Item Name: Crosstube Turning Detail

DART AEROSPACE LTD	Work Order:	77418
Description: Crosstube Assembly (205/212/412 High Fwd)	Part Number:	D212-664-141
Inspection Dwg: D212-664-141 Rev: D		Page 1 of 1

DRAWING NO. D212-664-141	TITLE XTUBE ASSY (205/212/412 HI FWD)	REV. D	DART AEROSPACE LTD ENGINEERING ORDER		D.E.O. NO. D212-664-141-D-1	SHEET NO. SHEET 1 OF 2	SCALE NTS
DRAWN	CHECKED	OP	MFG. APPR.	APPROVED	DE APPR.		
DATE 11.04.07	DATE 11.04.11		DATE 11.04.12	DATE 11/04/12	DATE 11.04.12

ADD AN INSPECTION WINDOW TO UNDERSIDE OF CROSSTUBE.

D212-664-141/-141B
ASSEMBLY DETAIL

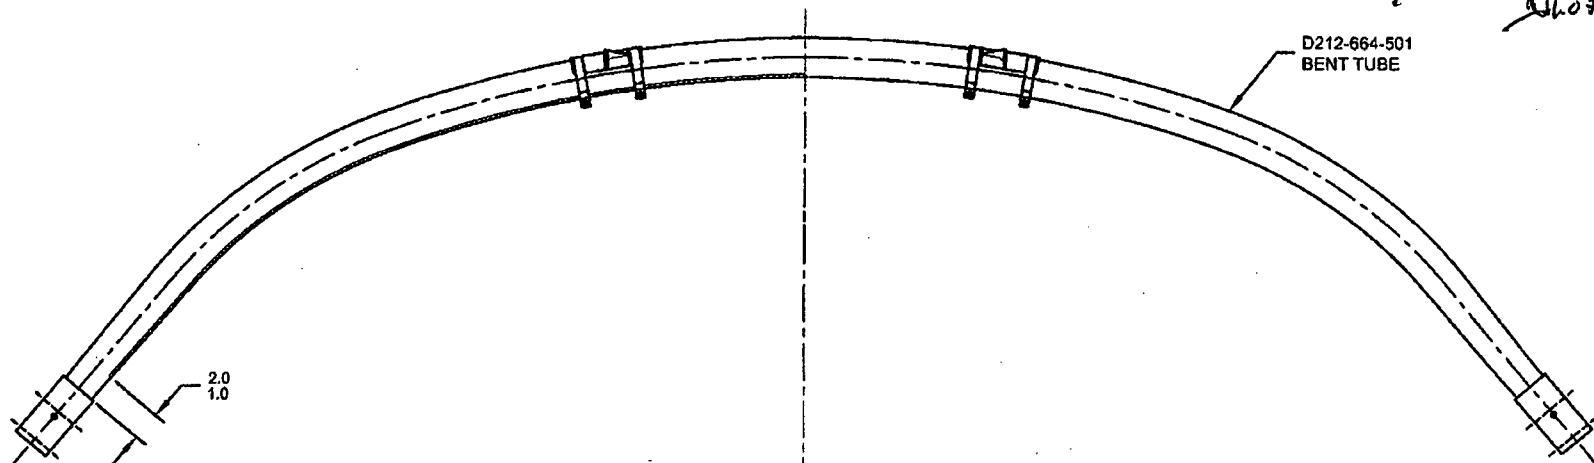
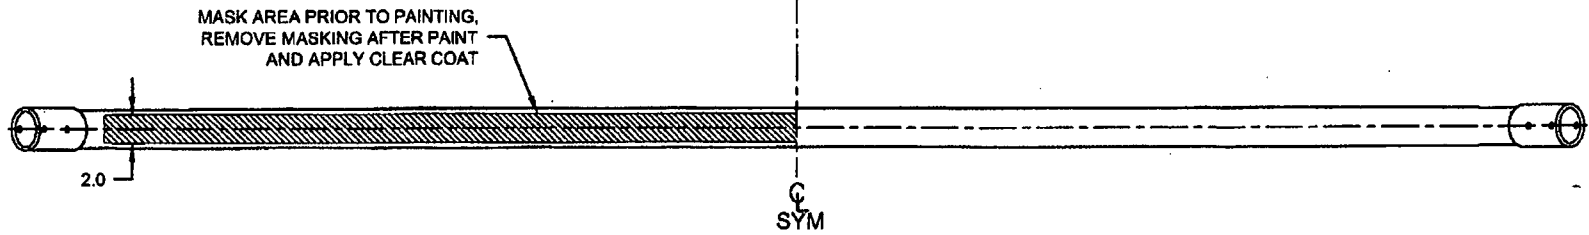
NOTES 2 OF SHEET 1 IS AMENDED AS FOLLOWS:

- 2) FINISH: CHEMICAL CONVERSION COAT PER DART QSI 005 4.1
PRIME INSIDE AND OUTSIDE PER DART QSI 005 4.2
MASK UNDERSIDE OF CROSSTUBE AS SHOWN (HATCHED AREA) AND
PAINT OUTSIDE PER DART QSI 005 4.2
REMOVE MASKING AND APPLY CLEAR COAT

- 2) FINISH: CHEMICAL CONVERSION COAT PER DART QSI 005 4.1
PRIME INSIDE AND OUTSIDE PER DART QSI 005 4.2
PAINT OUTSIDE PER DART QSI 005 4.2
